Planning Report

File: Take 5 Car Wash Date: May 23, 2022

Re: Variance, Conditional Use Permit, Site Plan Review - Take 5 Car Wash, 8301 University Ave NE

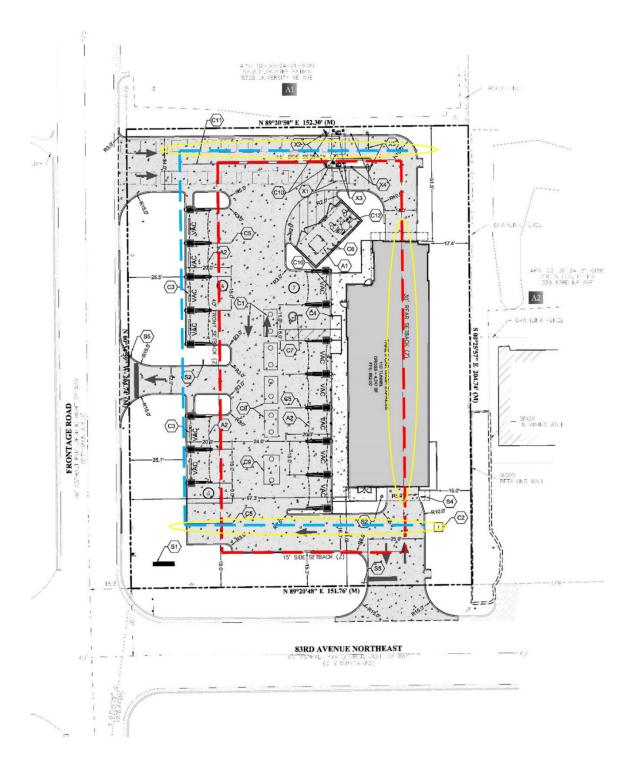
As mentioned, the site plan as submitted does not meet all setback requirements in the C-2 zoning district, therefore requiring a variance which the applicant has applied for along with this CUP application. The setbacks that do not meet requirements are described below and shown circled in yellow in the diagram on the next page.

- Corner side yard parking setback as shown is 15 feet, code requirement is 25 feet (south side of property adjacent to 83rd Ave NE)
- 2. Side yard parking setback as shown is about 3 feet, code requirement is 10 feet (north side of property)
- 3. Rear yard *building setback* as shown is 15 feet, code requirement is 30 feet (east side of property adjacent to Nelson Cheese and Deli).

The parking setbacks as proposed are a significant improvement to the existing parking lot setbacks, which encroach on the neighboring property to the north, and extend nearly to the property line at the south end of the property. While the application requires a variance to comply with the zoning code required setbacks, staff is in favor of granting this variance as an improvement to existing conditions.

The rear yard building setback also does not comply with code required setbacks, however, this is partially due to it being a corner lot, with frontage on two streets. The lot next to this one which is currently home to Nelson Cheese and Deli also fronts on 83rd, but the rear setback would be considered to be the north end of the site, not the east side. It should also be mentioned that in this case, if the building were required to comply with the zoning code setbacks, the stacking space would be lessened dramatically, potentially causing additional traffic and queuing issues. There are specific findings that

SITE PLAN

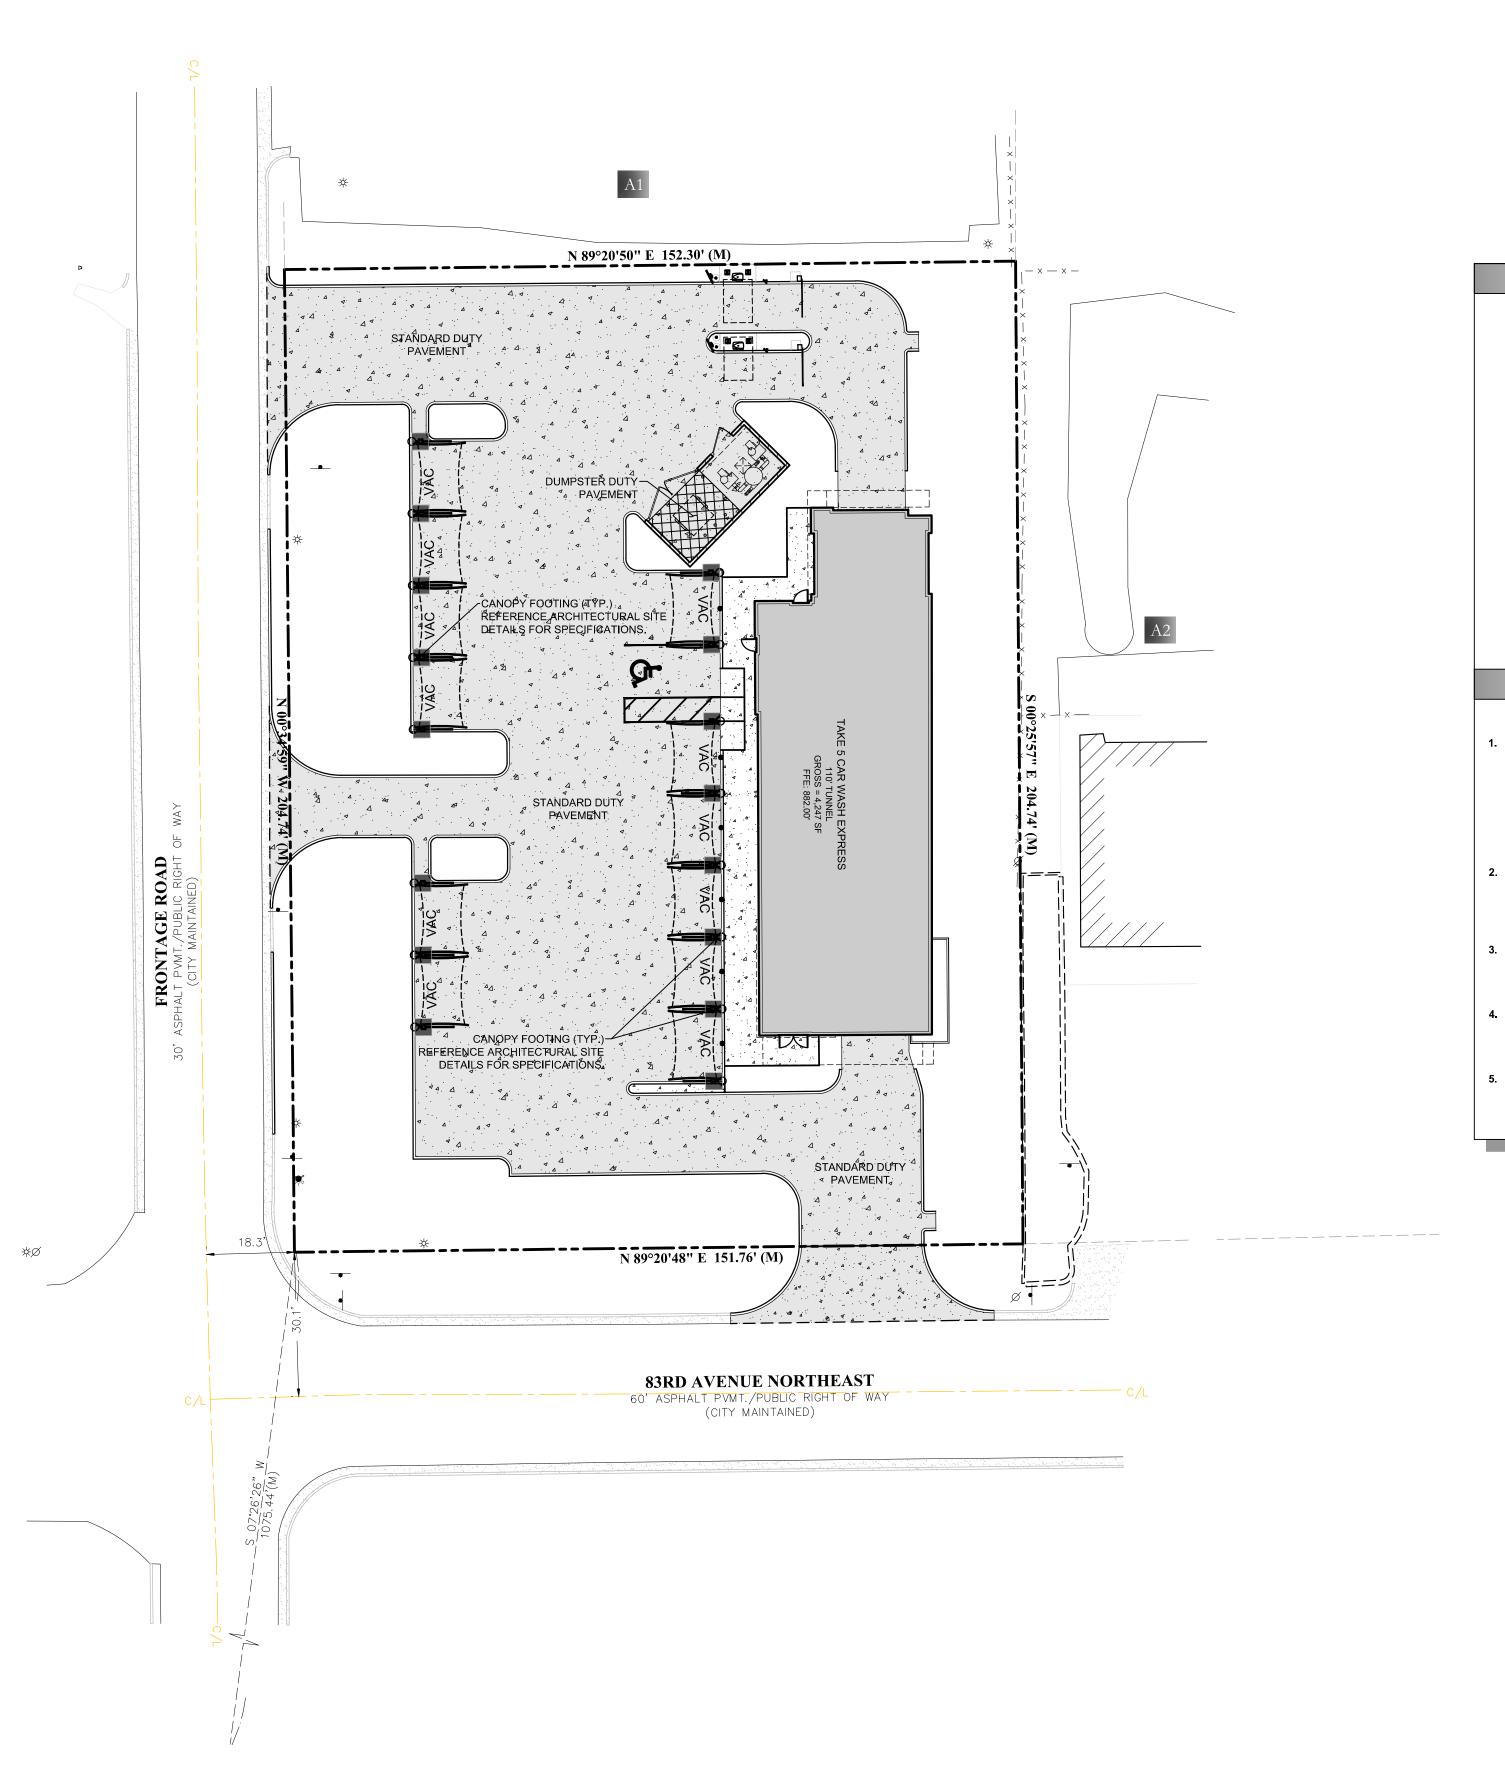
An issue with any drive-through type facility is adequate stacking and making sure that cars waiting in line don't interfere with cars on the adjacent street. The site plan submitted by the applicants shows 12 cars waiting in the pay station lines, and an additional 2 cars between the pay stations and the tunnel. This may be adequate, based on the submitted traffic study and analysis. Should traffic and queuing become an issue, there needs to be clear signage so that stacking onto the road is not allowed. The site plan currently shows stop signs at all exit points to ensure safe exiting of the site. If traffic and queuing becomes an issue, the City Engineer has included a condition that additional signage be installed to indicate queuing on University Ave Frontage road is prohibited.

There site plan shows 16 parking spaces in front of the building in the parking/vacuum area, including 3 standard parking spaces, 12 vacuum spaces and 1 handicap space. This would serve customers and staff for the facility. Spring Lake Park's parking standards require 10 spaces per lane in a commercial car wash. This facility may be different than what was imagined for a "commercial car wash" when the code was written. We recommend relying on the applicants' experience with their facilities to propose adequate parking.

- 10) Grading. Site plan shall be revised to create high points in all 3 driveways to prevent site drainage from draining directly on to 83rd Ave. NE or University Service Drive. Utilize proposed green space(s) for stormwater management.

UTILITY PLAN

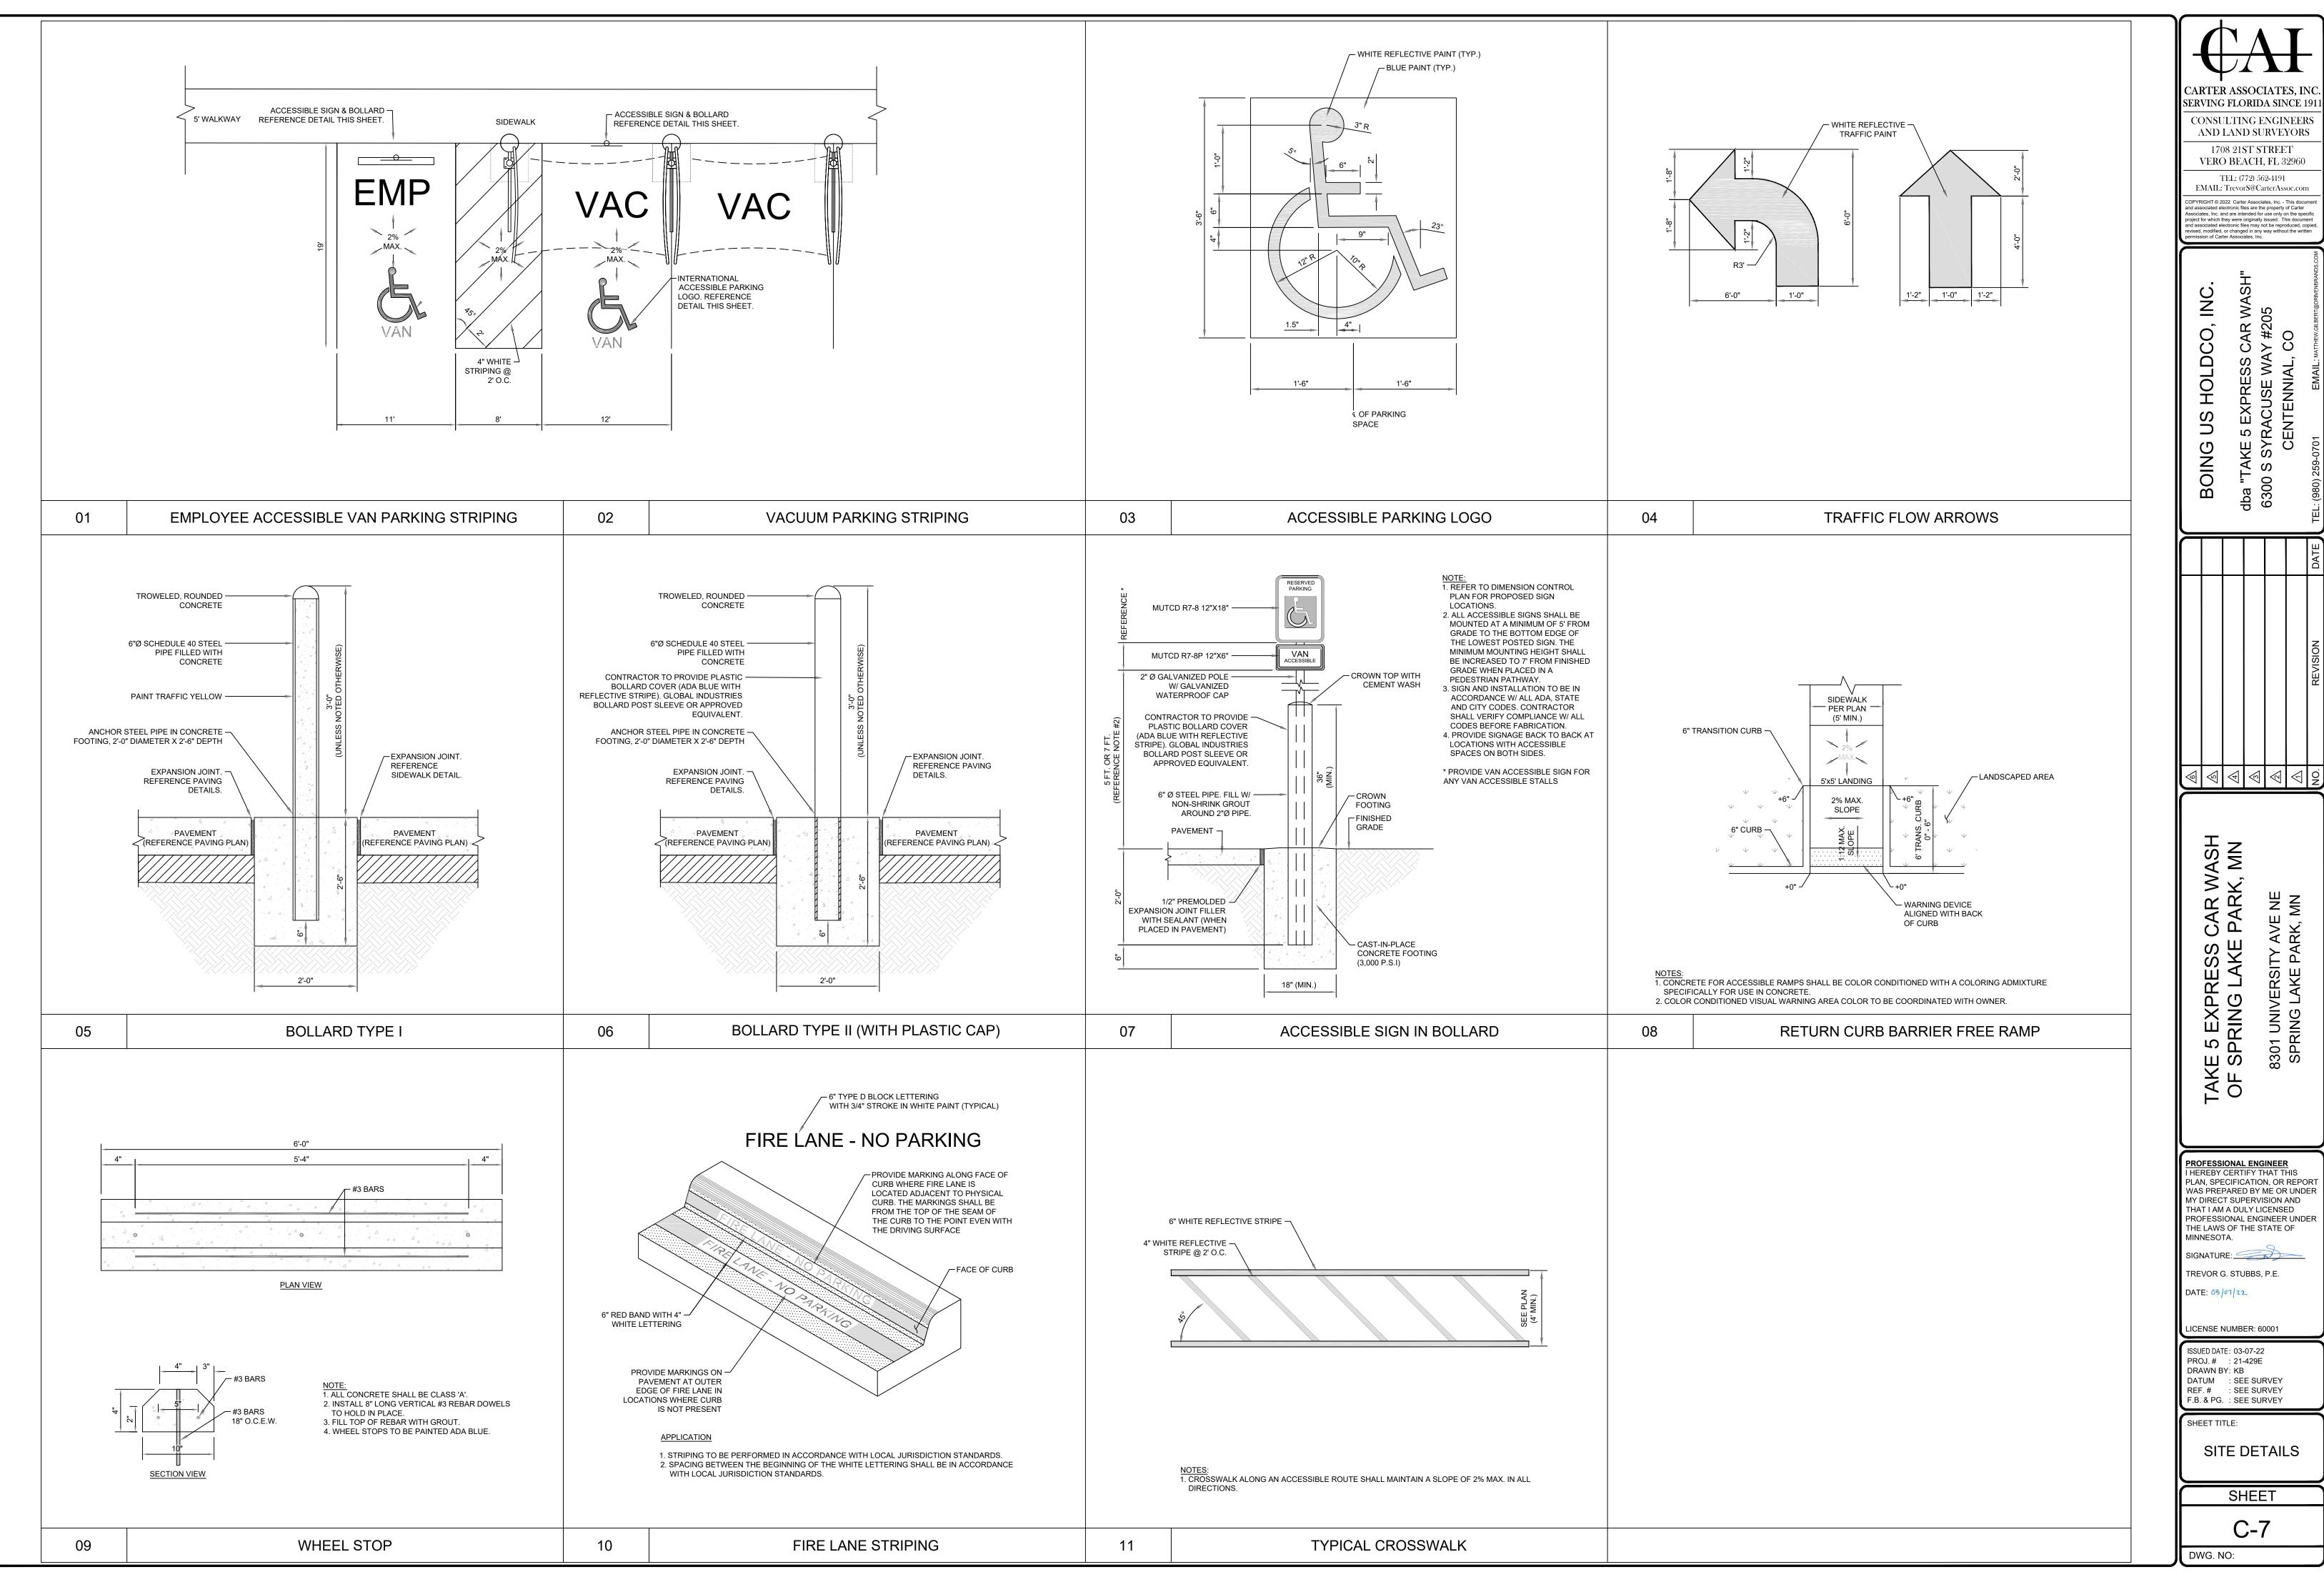
- 14) Sanitary Sewer. Show existing sanitary sewer service(s) on utility plan. Re-use an existing sewer line for site service (no new connection). Locate and plug any existing sewer service that is not to be used.

- 15) Water Works. Show existing water service(s) on utility plan. Locate and plug any existing water service that will not be reused (plug at the main).
